**ADMINISTRATIVE
LARGE RETAIL ESTABLISHMENT
SITE PLAN REVIEW**

FRAGMENT LOTS 4A, 5A, & 7A, TRACT A
ANCHORAGE VILLAGE SUBDIVISION

AUGUST 2015

JL PROPERTIES, INC.
REAL ESTATE DEVELOPMENT & MANAGEMENT

APPENDIX E:
Landscaping Plans

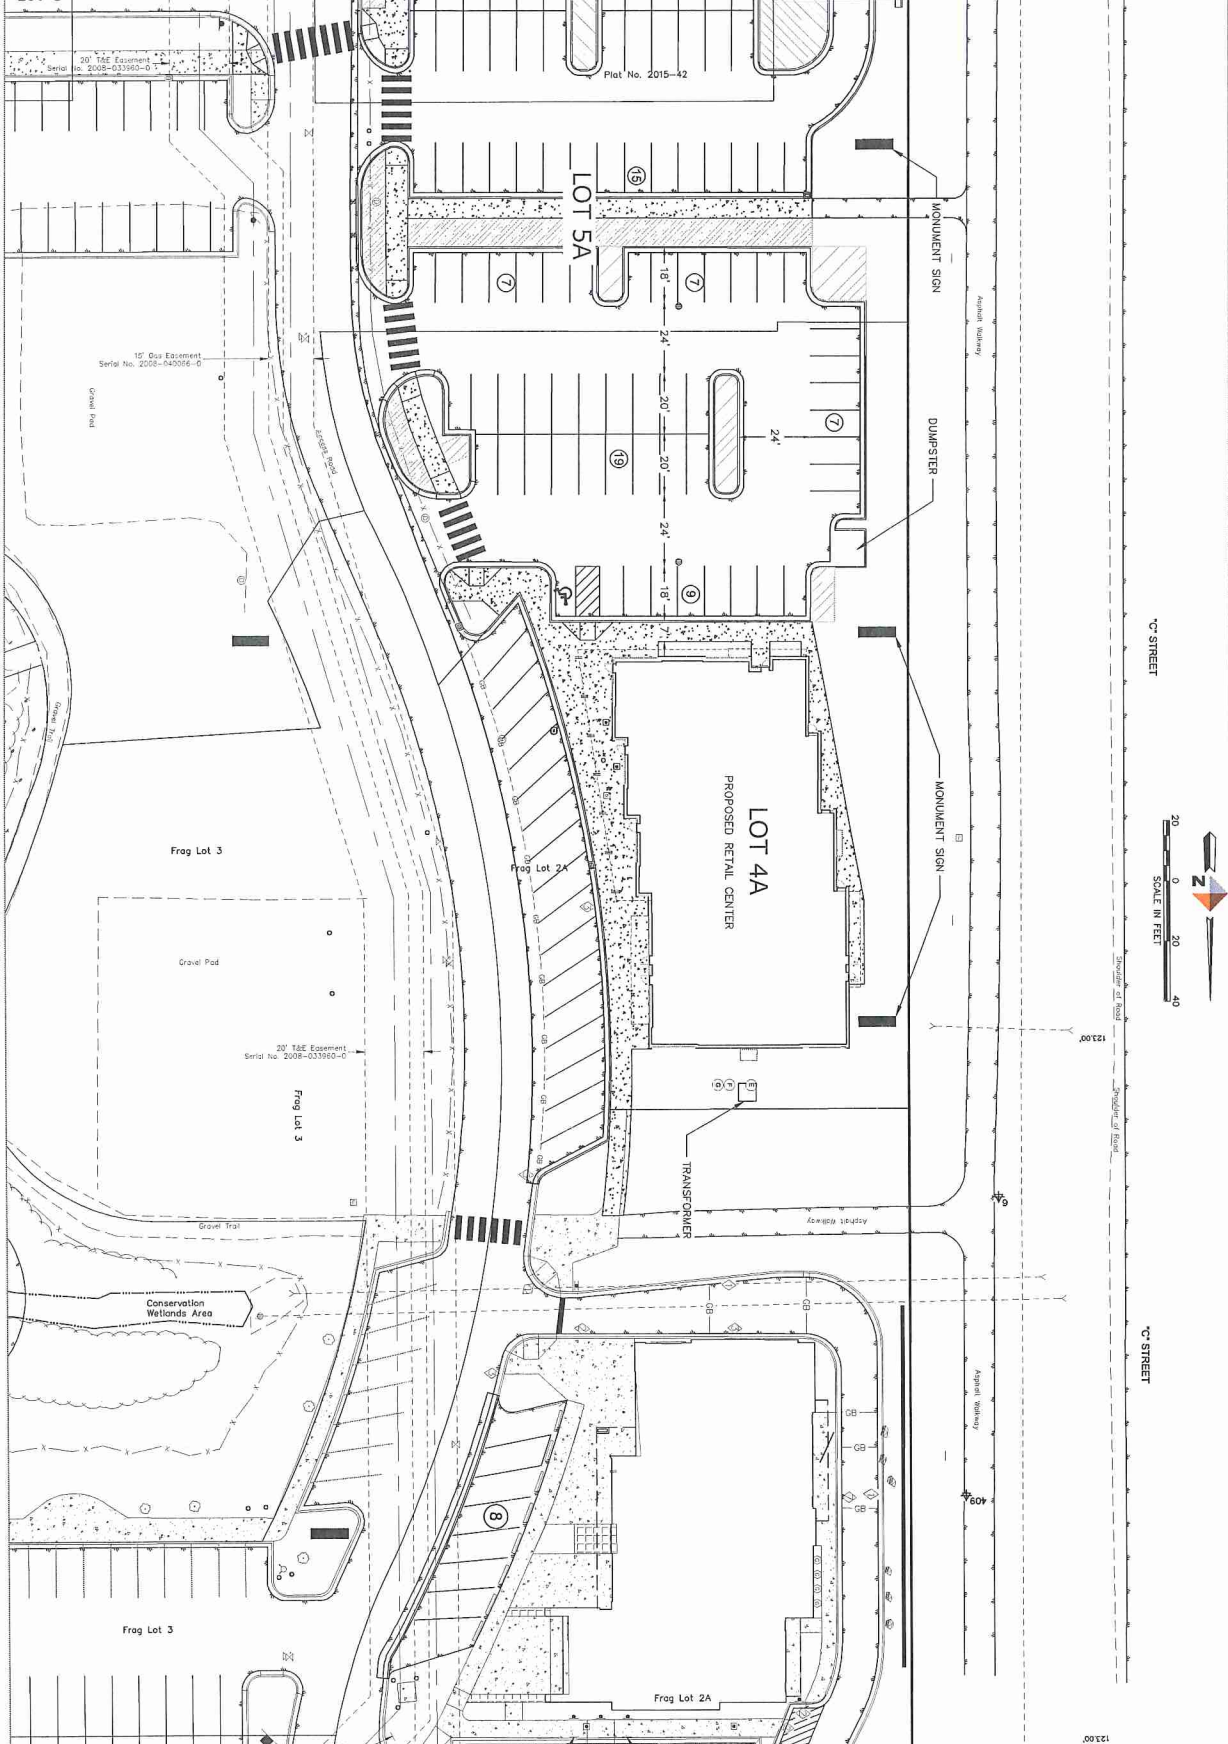
- ✓ Dimension the parking lot to include parking spaces and drive aisles on site plans.
- ✓ Dimension the walkways.
- ✓ Show vehicle circulation (arrows).
- ✓ Label Lot 7 on bldg. footprint on sheet L1.
- ✓ Provide 11 x 17 copy of landscape plan – may need to shift planting details and plant schedule to 2nd sheet to make plant symbols legible on plans.
- Label sign locations.
- Provide dumpster screening details.
- ✓ Concrete pattern missing from sheet L1 for south side curve in walkway – pattern shows on civil sheet.
- ✓ Indicate snow storage space or alternative strategy.
- Indicate loading berths on site plans.
- ✓ Watershed sign-off form – was this submitted earlier for previous reviews at this location?

*show frag show circulation routes drive aisles
label lot 7 on bldg. footprint for sheet L1*

submit 11/17 landscape plans

*lot 7 curve of walkway - no concrete
on landscape plan pattern*
